# AGENDA

ARCHITECTURAL REVIEW BOARD MEETING  
CITY HALL, 385 SOUTH GOLIAD STREET, ROCKWALL, TEXAS  
MARCH 11, 2025 IN THE CITY COUNCIL CONFERENCE ROOM AT 5:00 PM

**TO:** Planning and Zoning Commission  
**FROM:** Henry Lee, *Senior Planner*  
**DATE:** March 11, 2025  
**SUBJECT:** SP2025-007; *Amended Site Plan for 1407 S. Goliad Street*

**TO:** Planning and Zoning Commission  
**FROM:** Bethany Ross, *Planner*  
**DATE:** March 11, 2025  
**SUBJECT:** SP2025-008; *Amended Site Plan for 401 W. Rusk Street*

**BUILDING ELEVATIONS**  
CONCEPTUAL DESIGN

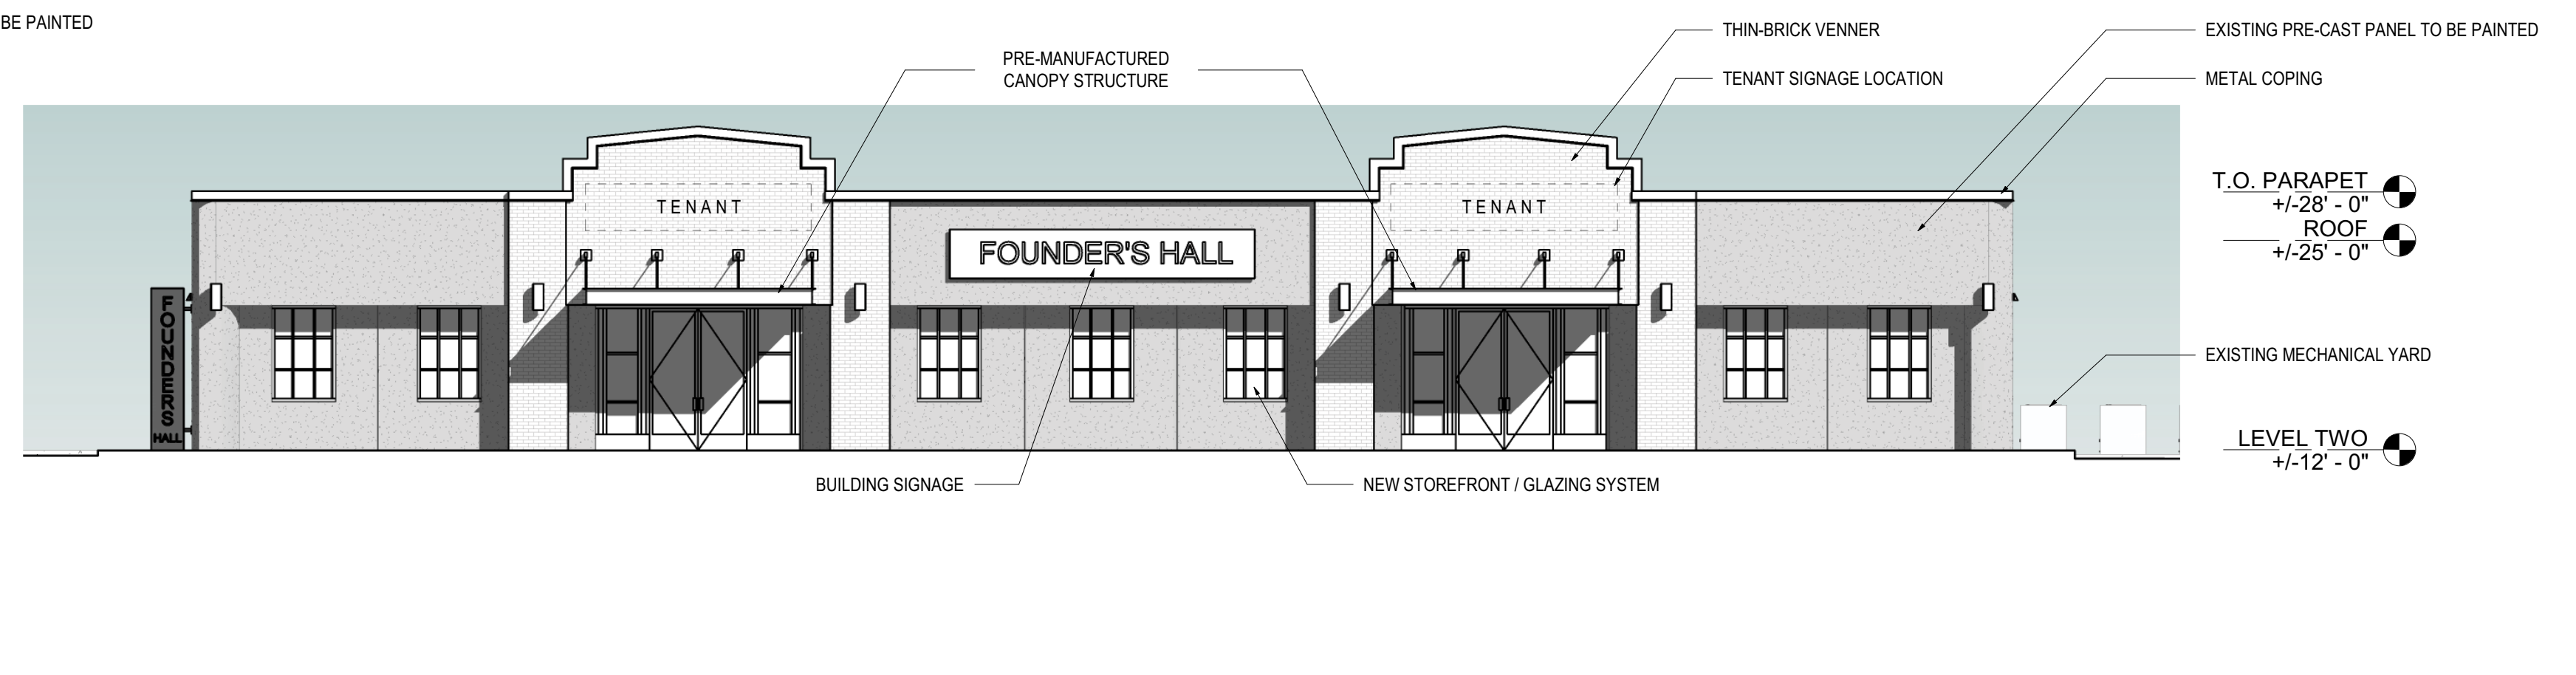
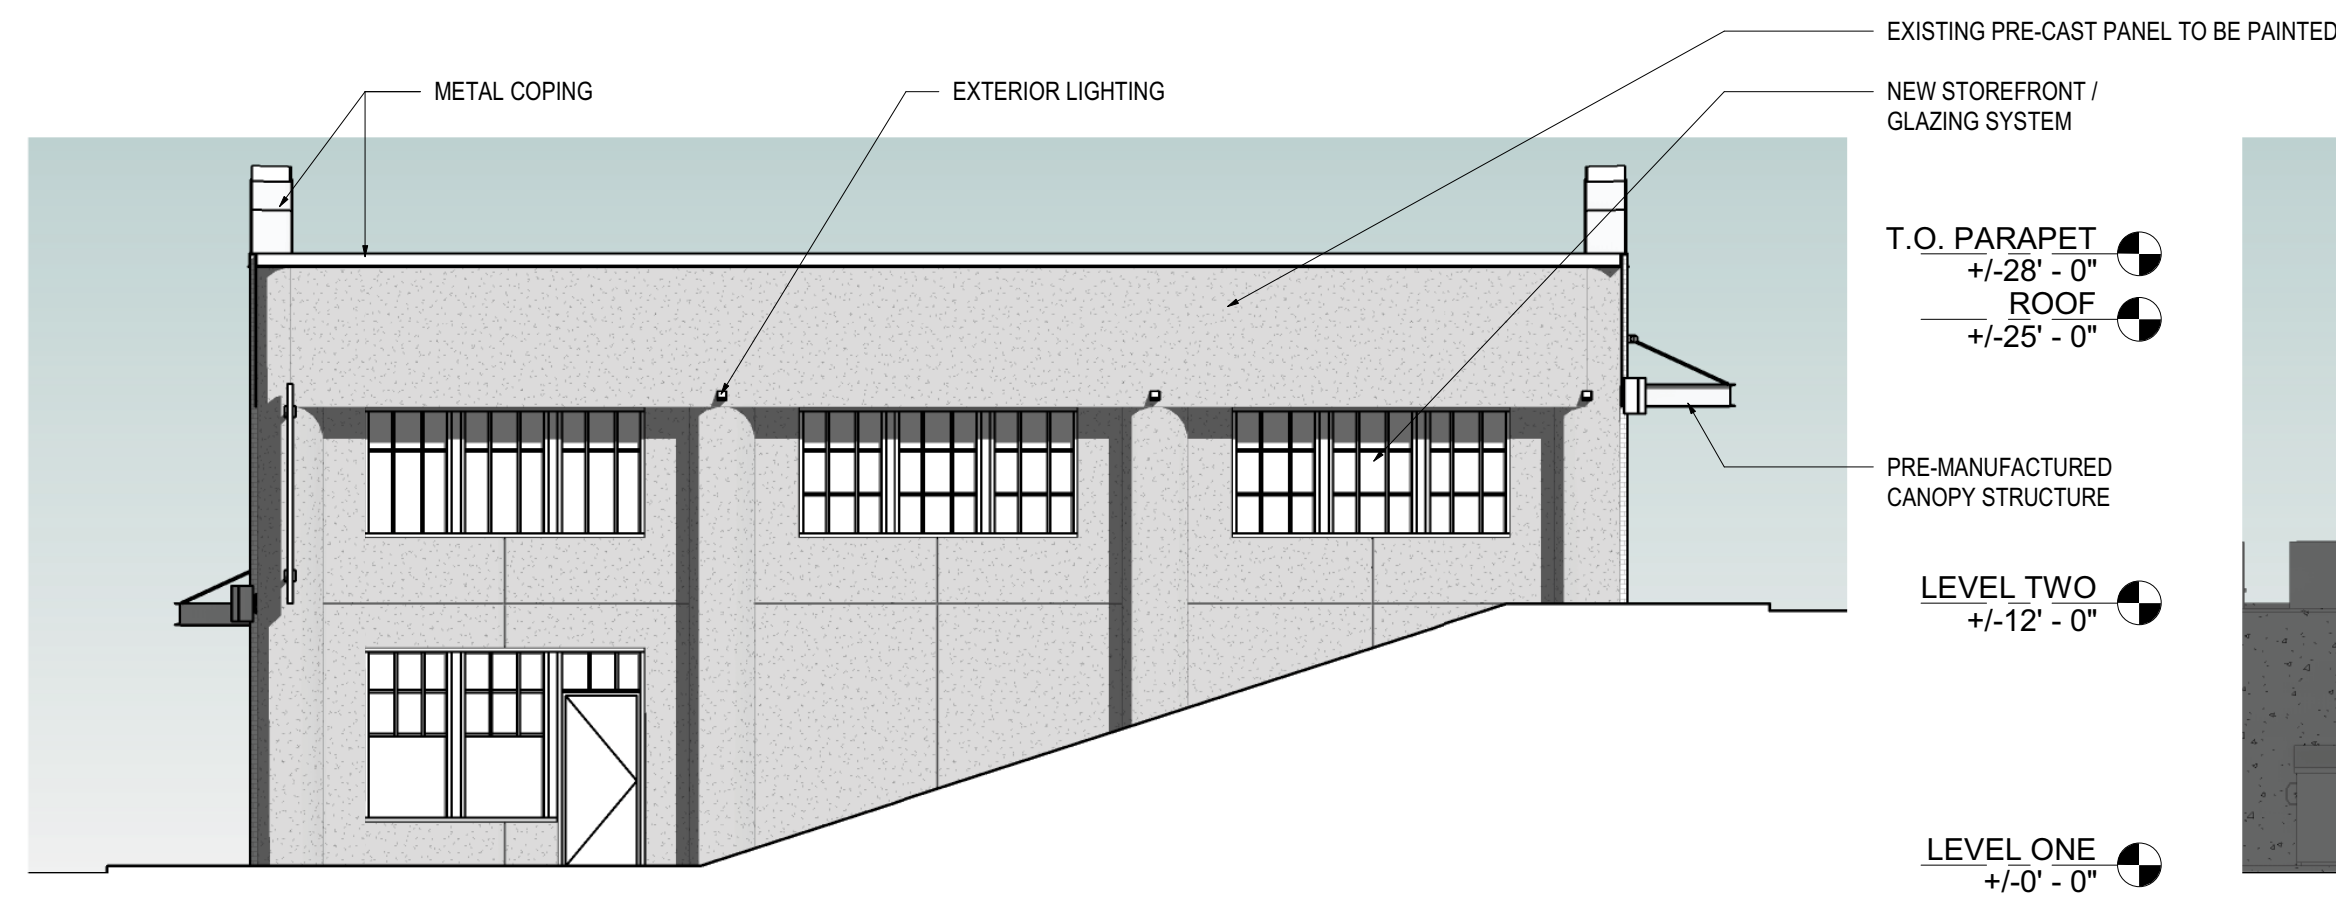
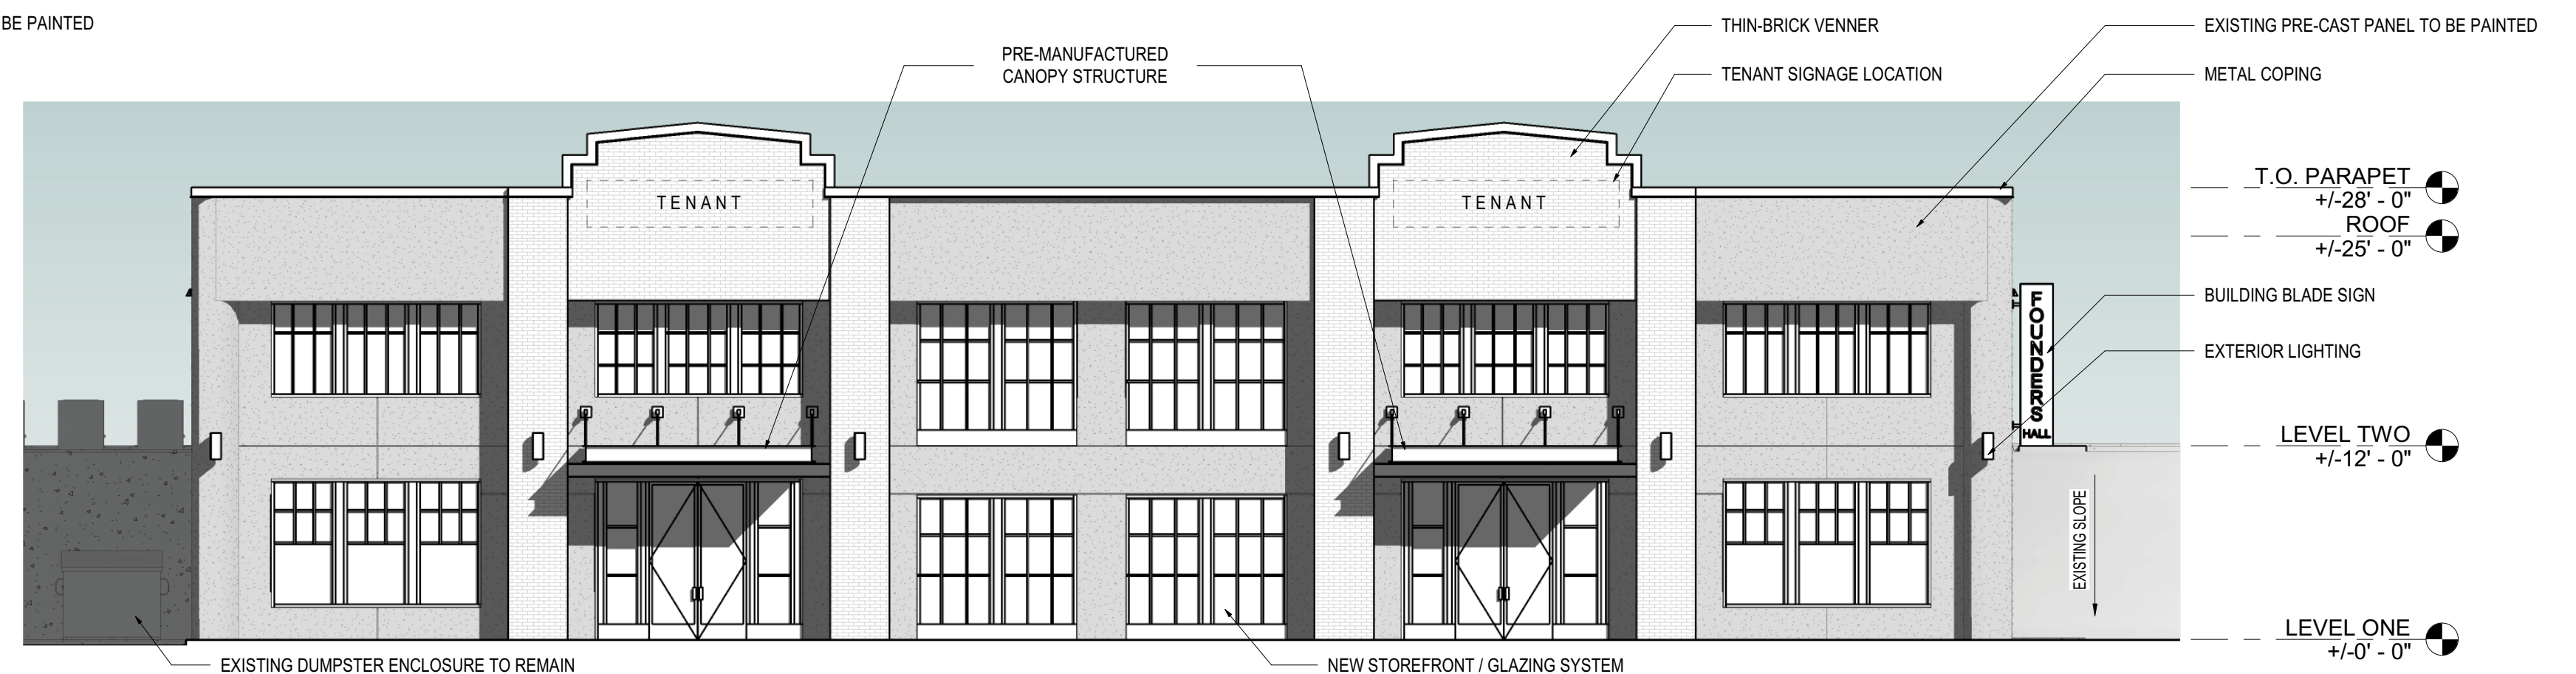
Specifically, the applicant is proposing to add a red thin width brick to the entrances of the building. The applicant is also proposing to add two (2) awnings to the front of the building, and two (2) awnings to the backside of the building. This addition will also include a parapet extending up at the entrances of the building. In lieu of finishing the backside of the parapet in the proposed red thin width brick, the applicant has agreed to paint the backside of the parapet a complimentary color to the proposed brick exterior.

- (1) Roof Design Standards. Projecting elements and parapets that are visible from adjacent properties or public right-of-way shall be finished on the interior side using the same materials as the exterior facing wall. This will require the approval of an exception by the Planning and Zoning Commission [*Subsection 04.01. (A)(1); Article 05, UDC*].

- (2) Exterior Building Color. The dominant color of all buildings (*including above grade parking structures*) shall be muted shades of warm gray, red, green, beige and/or brown. Black, gold and stark white shall not be used except as an accent color. There are no restrictions on accent colors which comprise less than one (1) percent of the building face, except that florescent colors are prohibited. In this case the applicant is proposing the color iron ore -- *which is considered to be a darker gray as opposed to a warm gray --* on over 80% of the building's facades. This will require the approval of a minor waiver by the Planning and Zoning Commission. [*Subsection 04.07(C)(2)(a); Article 05, UDC*]

1. M5.1: Point of clarification. No Roof Top Units will be on the building.
2. M5.2: Updated 03/04/25 renderings show this.
3. M5.3: Request to paint the back side of rooftop parapet caps SW 7069 Iron Ore to match the rest of the paint on the building. Updated 03/04/25 renderings show this.

4. M5.4: SW 7069 Iron Ore has been selected by our architecture team as the best match to our selected brick (Acme, Pine Hall – Alleyway). We believe the building looks best in this color as well and hope that you agree. See the 03/04/25 renderings for design aesthetic.

5. M5.5: Because this is a split-level structure, adhering to this requirement would entail wrapping the entire building in brick. We wanted to move away from the current building design by adding parapet caps at the entrances to make the structure appear taller and more grand. Carrying the brick band vertically at these locations rather than horizontally as the intent of this requirement indicates would be detrimental to the goal of this design.

6. M5.6: The two operating storefront faces of this building (East & West) do not face the surrounding roads (North & South sides). Placing brick on the road-facing sides does not make sense and detracts from the aesthetics of the building. The view of the North & South walls from the surrounding roads will be impeded by existing trees. See the 03/04/25 renderings for design aesthetic.

PHOTOMETRIC PLAN  
 SCALE: 1" = 12'-0"

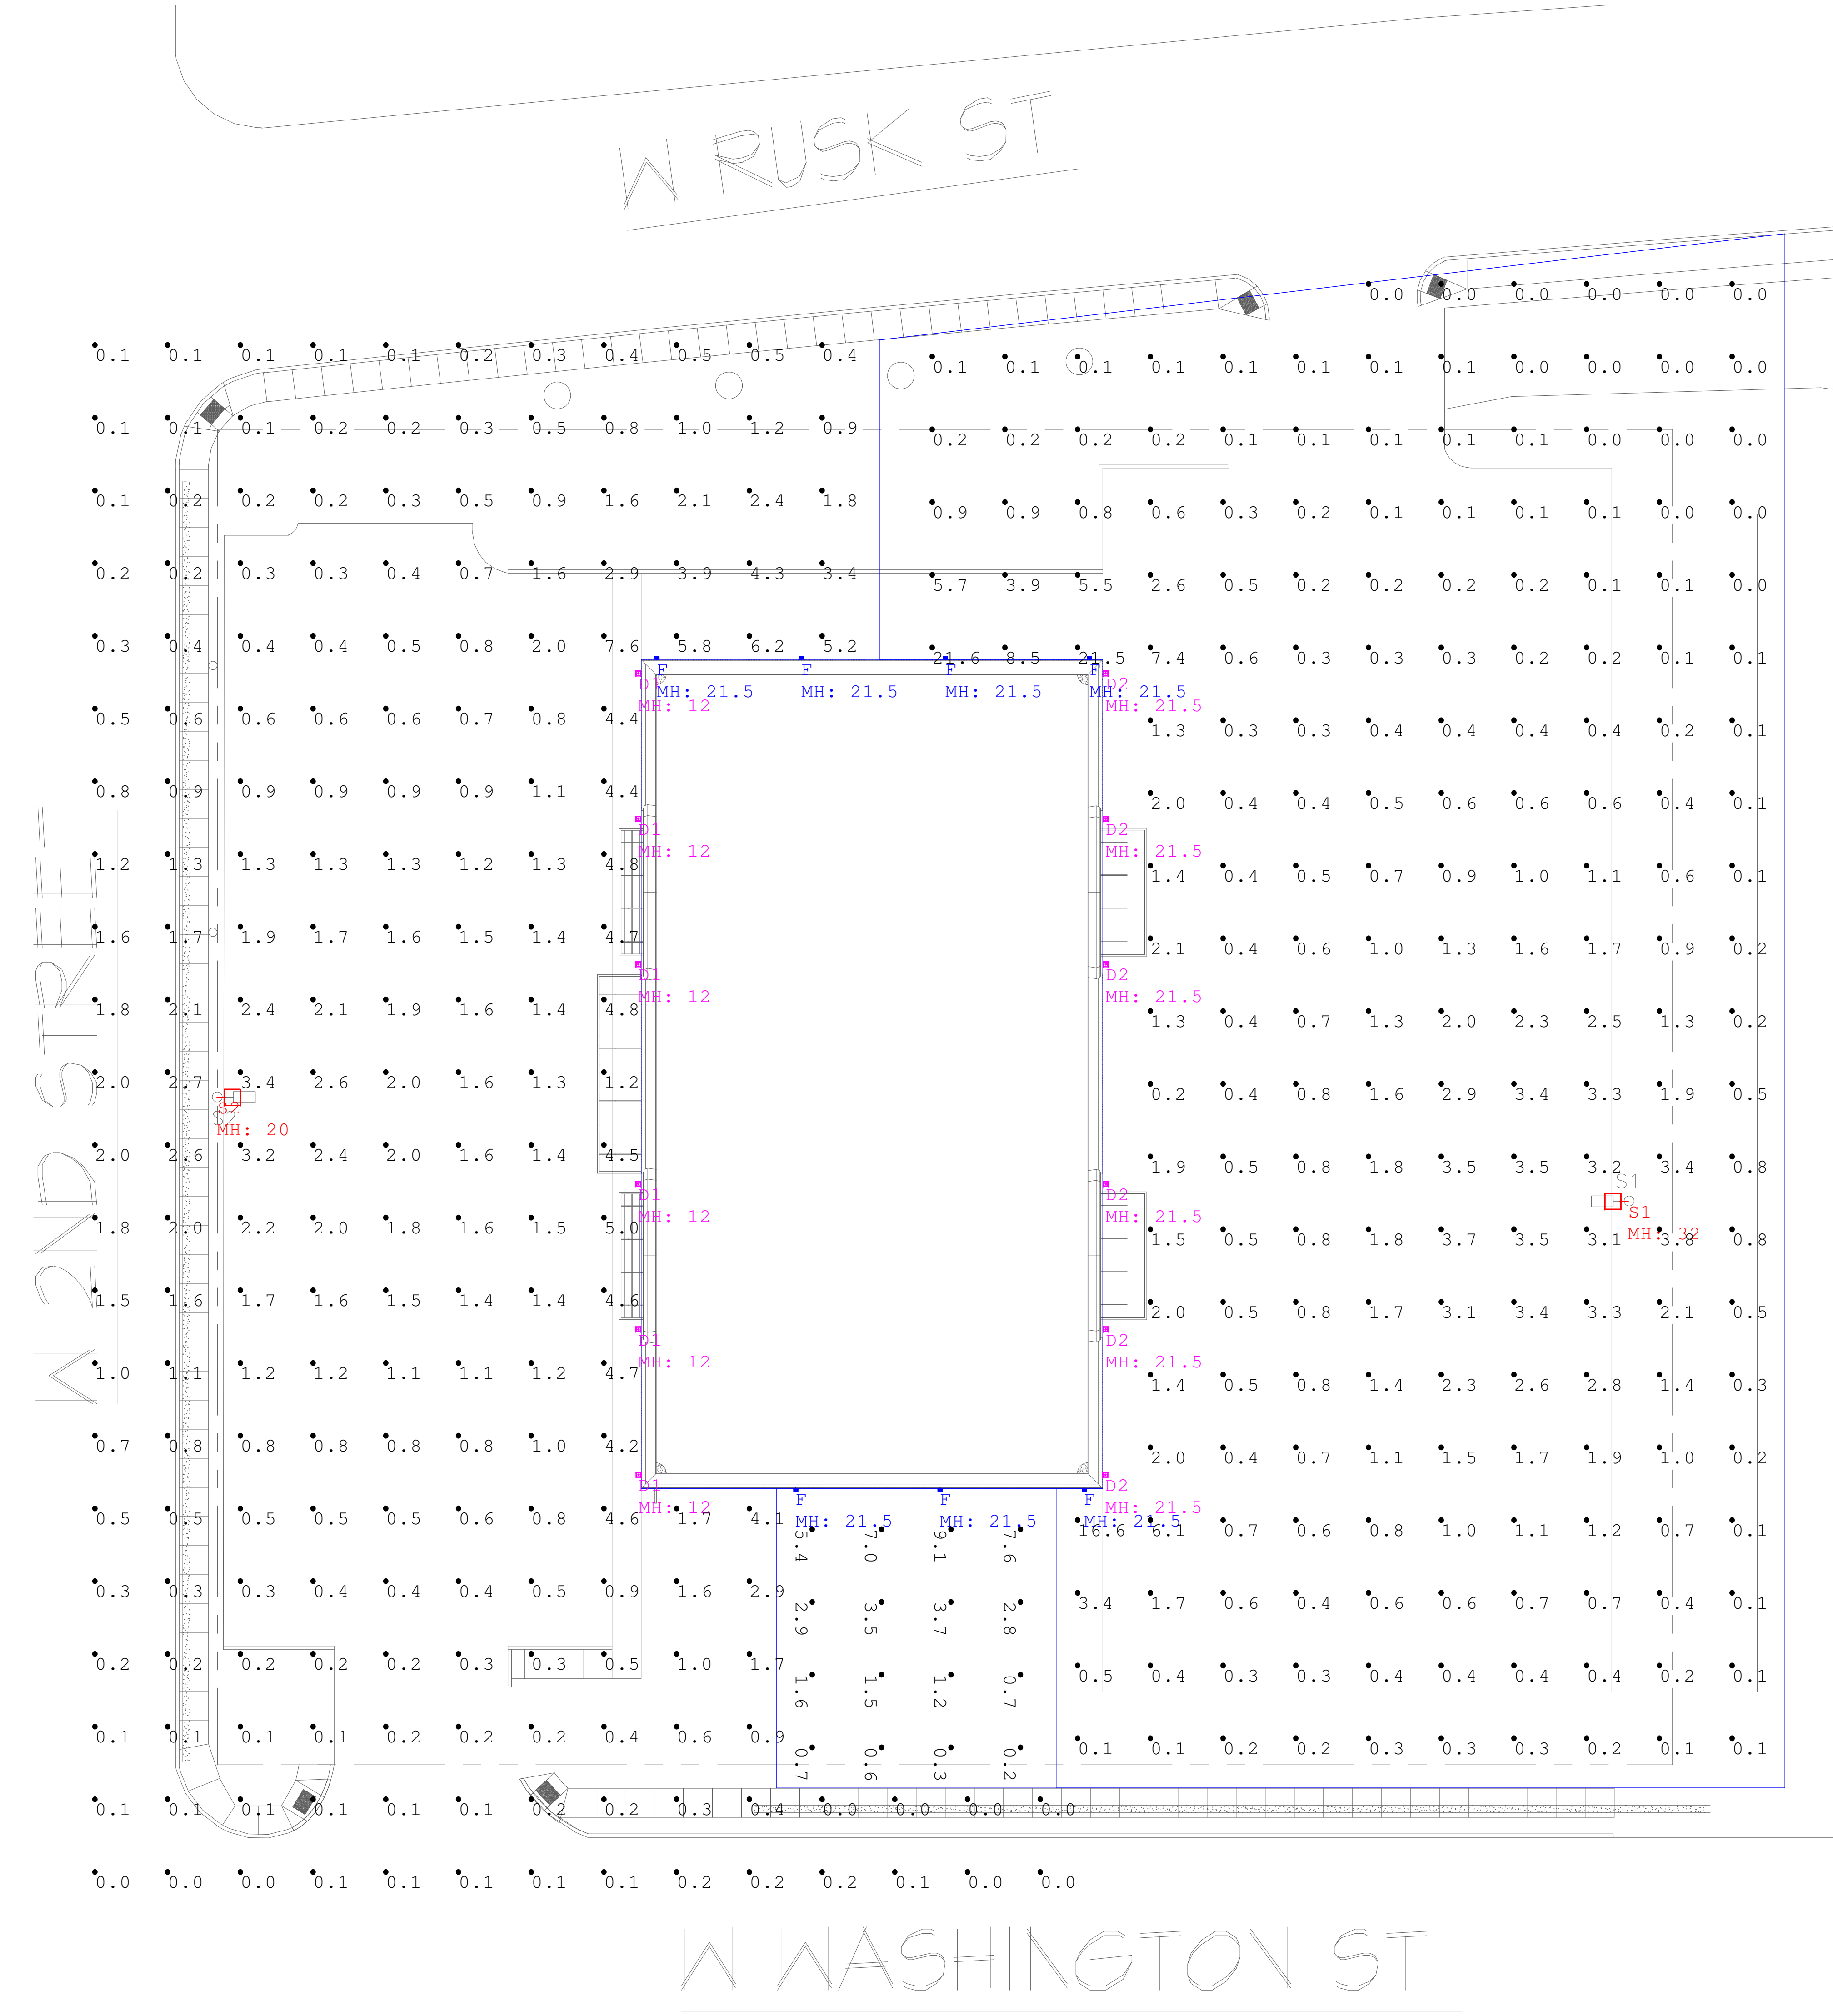
As part of the review for this case, staff has indicated to the applicant that the Photometric Plan will need to be changed to meet the lighting and photometric standards of the Unified Development Code (UDC), and this can be considered a condition of approval for this case. The applicant's proposed scope of work is mostly in compliance with the Unified Development Code (UDC) -- *meeting both the general requirements set forth by the UDC and the SH-66 Overlay District (SH-66 OV) --*; however, staff has identified one (1) exception and one (1) waiver to the requirements of the UDC. These are as follows:

Per Lighting Schedule on E3.101, light poles are 20'.

7. M5.7: Bicycle parking has been added on the submitted site landscape plan.
8. M6.1: The intent of adding site light poles to each parking area is to increase the safety and comfortability of our tenants and patrons. Due to the size and existing layout of this lot, any light pole placed at the far end of the parking lot (the area receiving little light from the building)

would affect the 0.2 FC requirement at the property line noted here. If we need to remove the lighting to fit the requirement then we certainly will.

9. M.6.2: Light Poles are already 20' per the Lighting Schedule shown on E3.101. This schedule was placed on the updated photometric plan in this submission.
10. I.7: Included in this letter.
11. M.8: Included in this letter.
12. Reviewer Comments:
  - a. Building 02/20/25, Craig Foshee: The existing dumpster enclosure (North wall facing West) will be painted to match the building.
  - b. Parks 02/18/25, Travis Sales: Landscape Plan included with submission now showing gallon sizes.
